ORIGINATION FORM

Proposed Revisions to a Standard Plans Index
(Please provide all information — Incomplete forms will be returned)

Index Number: 458-110
Sheet Number (s): 1 of 2
Index Title: EXPANSION JOINT SYSTEM - POURED JOINT WITH BACKER ROD

TYPICAL SECTION THRU JOINT

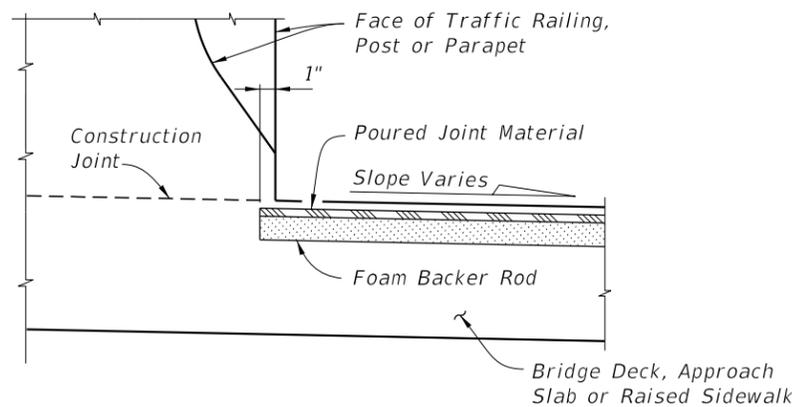
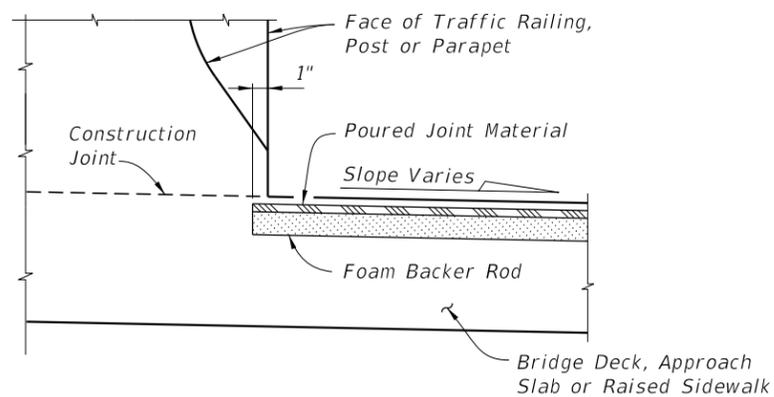
Sheet 1: Changed annotation about form material to indicate it should be removed completely.

Sheet 1: When these expansion joint fail there is a concern that the foam form material left in from casting would trap incompressibles and and cause other maintenance issues. A meeting of the DSMEs on the issue brought a consensus that when installing these joints the foam should be completely removed rather than just enough to facilitate the backer rod and the sealant.
